The PV logger comm fail: what the controller does today, and the small change that stops it

Erbil plant, InteliNeo 5500 master, PLC sheet 10. Written from the archive and history exported on 14 October 2026.

Sheet 10 after the change

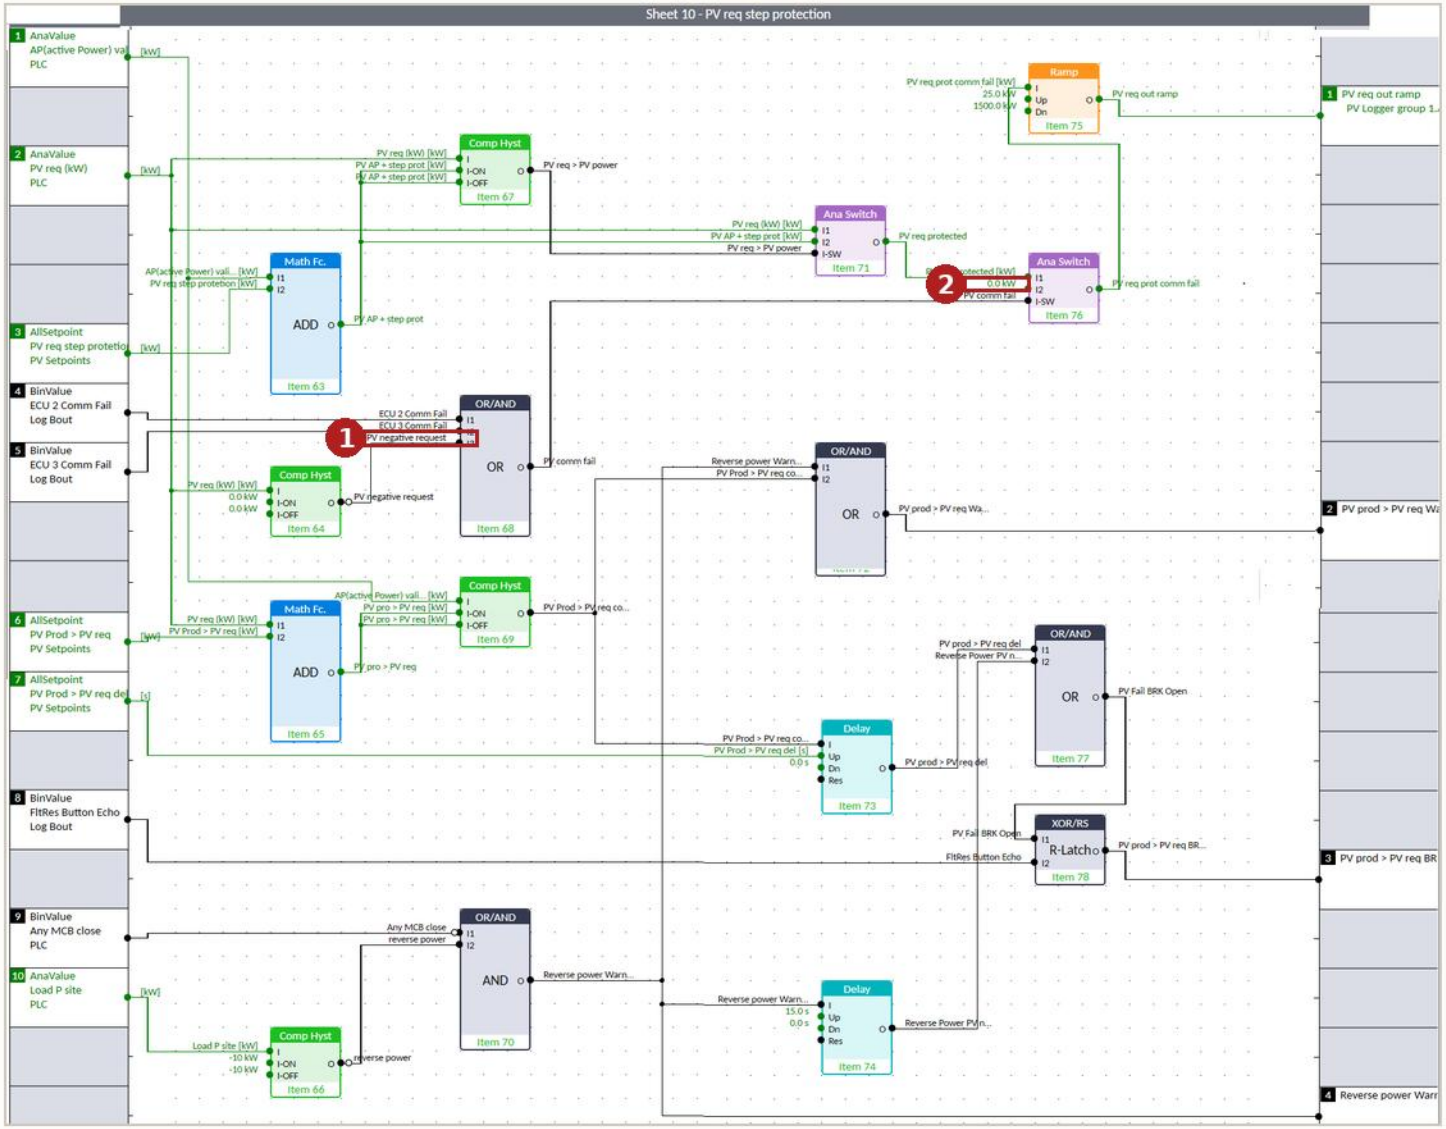
We leave the switch, we leave the ramp, we leave every protection on the sheet. We change only what sits on the switch's second input: instead of a fixed zero, it is wired to the switch's own output. Now, when a reply is missed, the switch simply repeats the last value it sent. The solar plant keeps producing what it was producing, the gensets stay where they were, and the UPS logic has nothing to react to. When the link is back the fresh request takes over, and because the plant never dropped, the request is already where it should be.

Two small things come with it. The block in front of the switch, Item 68, used to flip it also when the request was zero or below. That was a harmless guard while the second position was zero anyway; with a hold it would be wrong, because if the controller genuinely wants zero it must get zero. So that third input comes off, and Item 68 reacts only to the two comm fail signals. And there is one new block, a five minute timer on the same signal, that raises a flag we called "PV comm lost". Nothing acts on it yet. It is there so the alarm list can show that the logger has been silent for five minutes, and so that later, if the plant wants it, sheet 3 can open the PV breakers on purpose instead of leaving the inverters running blind.

1. Item 68 now reacts only to the two real signals, ECU 2 and ECU 3 comm fail. The third input is gone.

2. The same switch, now Item 77, has its own output on its second input. A missed reply makes it repeat the last value. The inverters see no drop, the gensets see no step.

3. Item 65 is new: a five minute timer on "PV comm fail". When it runs out it raises "PV comm lost", sheet output 5. For an alarm now; for sheet 3 later, if the plant agrees.

Sheet 10 today

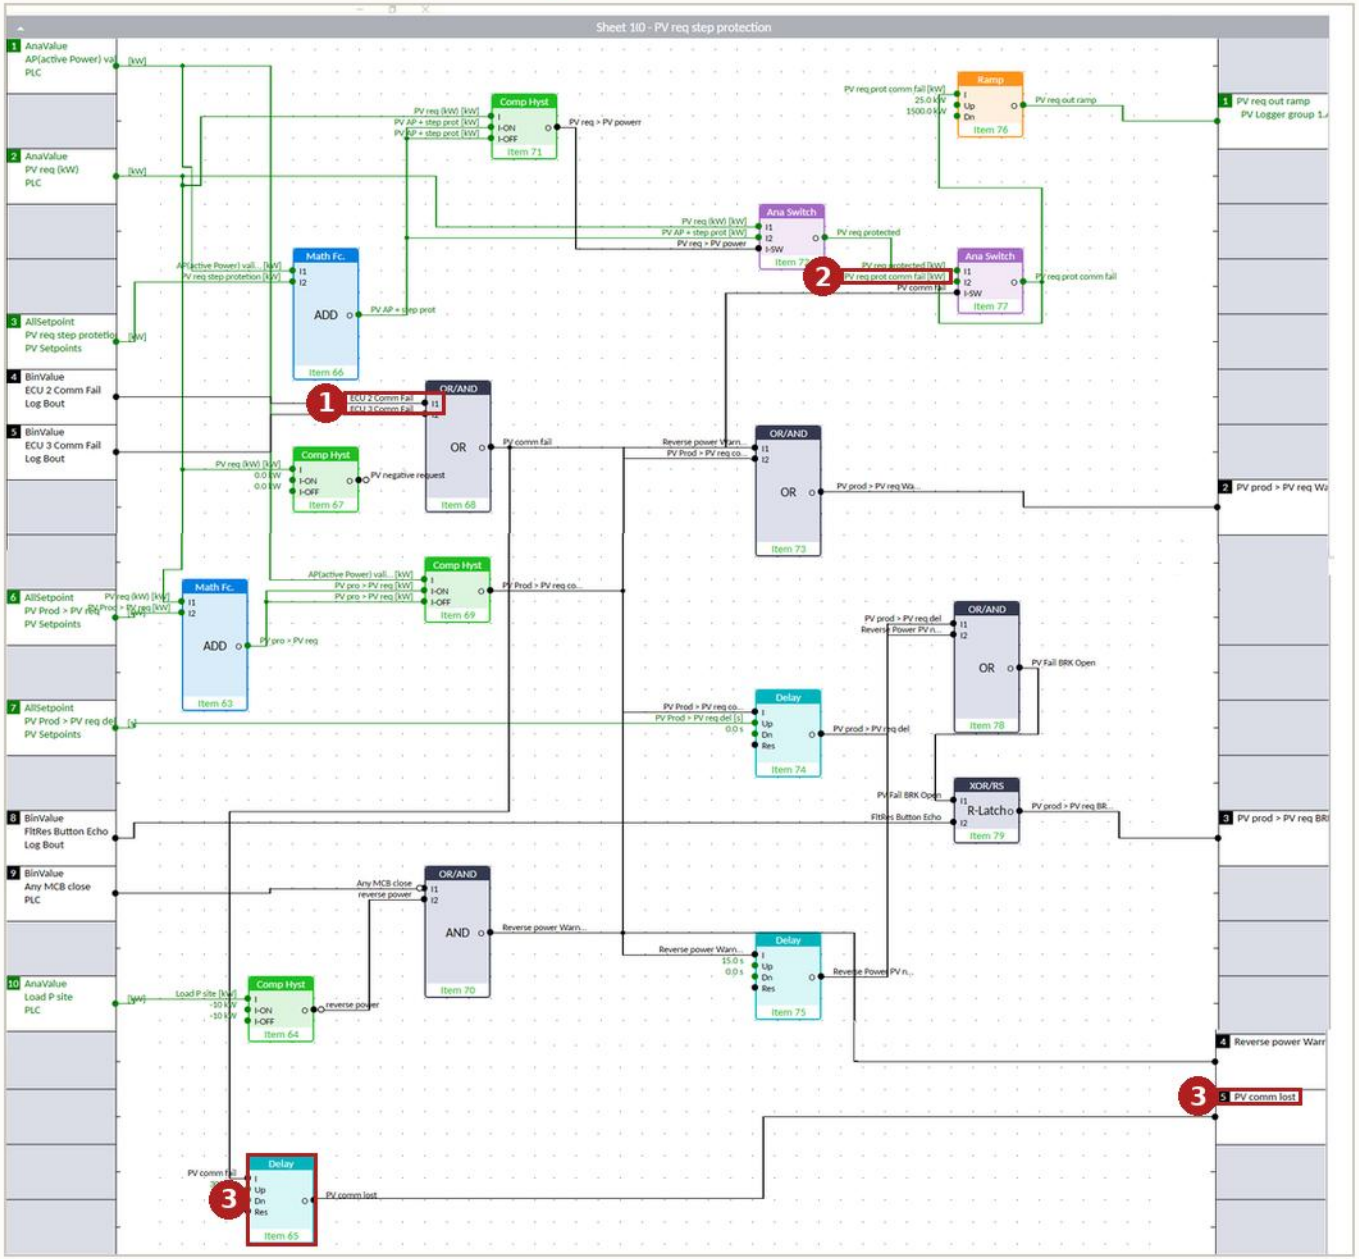
1. Item 68 decides when the request gets cut. It fires when either PV logger session misses a reply, and also when the request is zero or below.

2. Item 76 is the switch. Its second position is a fixed 0.0 kW. The moment Item 68 fires, that zero goes out to the logger, and the whole solar plant is told to stop.
